Proposed Change No. 120
Supplement No. 1

YANKEE ATOMIC ELECTRIC COMPANY

April 17, 1975

Pursuant to Section 50.59 of the Commission's Rules and Regulations and your request for additional information regarding Reference 2, the Yankee Atomic Electric Company hereby submits the following Supplement No. 1 to Reference 2.

FIG. 14—Cold Water Performance of Pump at 1800 RPM

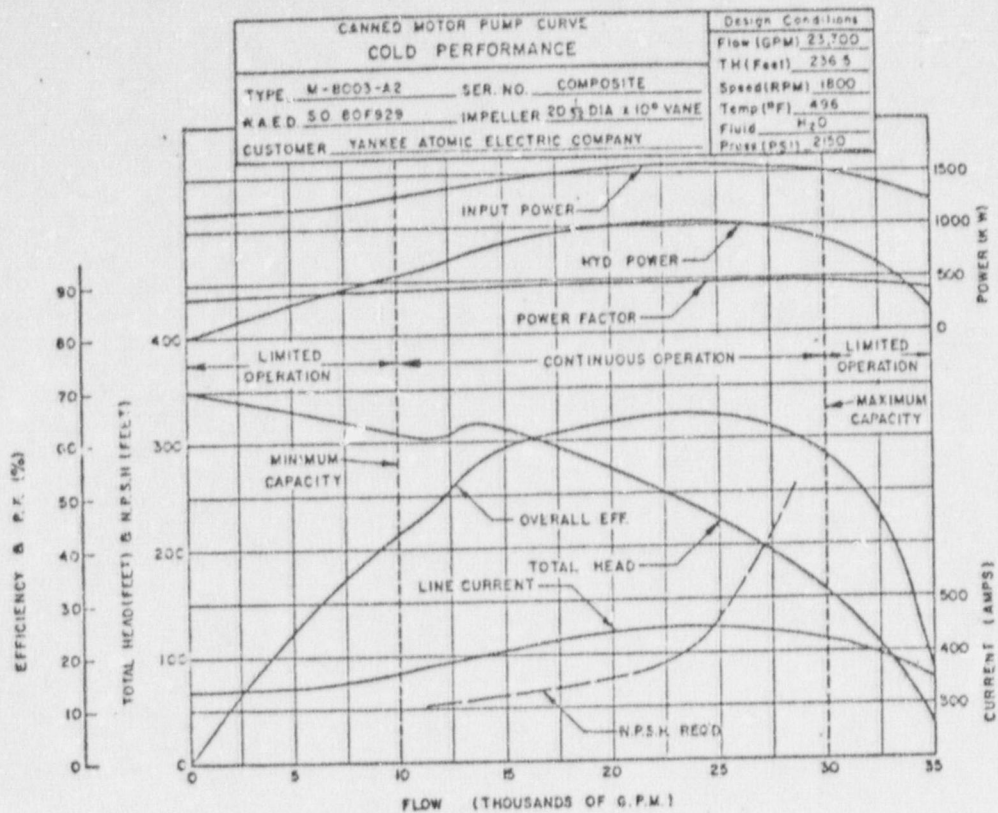
Your approval of Change No. 97 on April 14, 1972, was based on information submitted relative to the operation of the low main coolant flow trip using relays to monitor the electric current to each main coolant pump. The bases for the selection of the high and low current setpoints were given in Reference 4, Attachment B, "Additional Information on Proposed Instrumentation and Electrical System Revisions." The following is an excerpt from the answer to Question B.5 in Attachment B:

"The low main coolant flow scram is initiated by monitoring the current to each of the four main coolant pumps. When pump current is below normal current, a loss of flow due to loss of pump driving power supply is indicated; and when the current is above normal, a loss of flow is anticipated due to a pump mechanical seizure or a motor fault."

The low setpoint senses loss of pump driving power supply by sensing the decreasing current which occurs due to loss of power to the pump. The high setpoint will sense increasing pump current due to pump mechanical seizure or a motor fault before the locked rotor current of 2150 amperes is reached and before the motor protective relays operate. Therefore, the setpoint ampere values are not critical and must only detect high or low current indicative of loss of power supply or pump mechanical seizure. With this type of anticipatory trip, it is not necessary to correlate actual flow to pump current.
